CERTIFICATE OF APPROPRIATENESS

Property: 215 W 16th Street, lots 41, 42 & 43, block 132, Houston Heights Subdivision. The property includes a historic 1,222 square foot, one-story wood frame single-family residence and a detached shed situated on a 10,200 square foot (75' x 136') interior lot.

Proposal: Alteration – Construct a 3,200 square foot two story addition and attached garage at the rear wall of the contributing one story residence.

SOUTH ELEVATION – FRONT FACING W 16th STREET

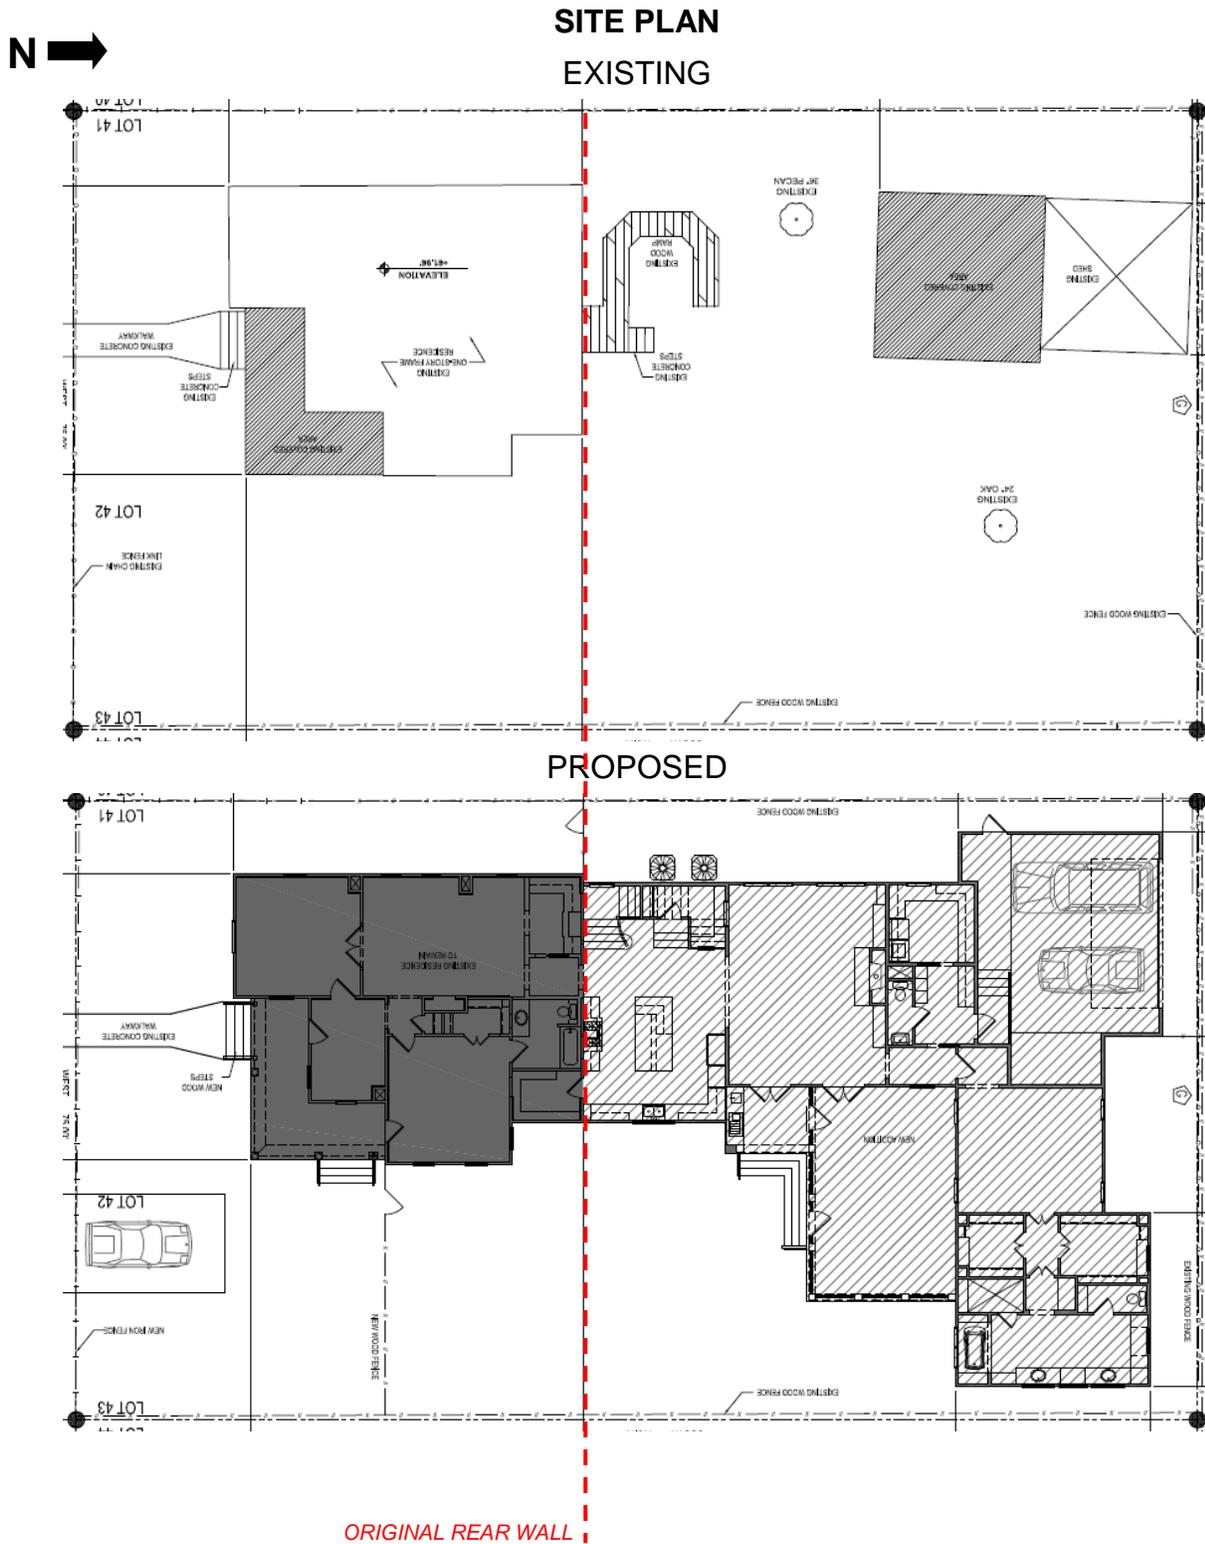
<i>The use of a different siding material with a distinctive pattern in the gables contributes significantly to the historical character of the residence and should be altered.</i> | | |

<i>The use of a different siding material with a distinctive pattern in the gables is a significant stylistic feature of this residence and should not be altered.</i> | | |

<i>Existing siding material in the gables represents significant historical material and should not be removed unless damaged beyond repair.</i> | | |

I support staff contention that the wood shingles should remain in the existing gable and should not be replaced with horizontal sheathing.

Recommendation: Partial Approval: Approval of addition and porch alterations. Denial of removal and replacement of shingles in gables.

HAHC Action: Partially Approved: Approval of addition and porch alterations. Denial of removal and replacement of shingles in gables.
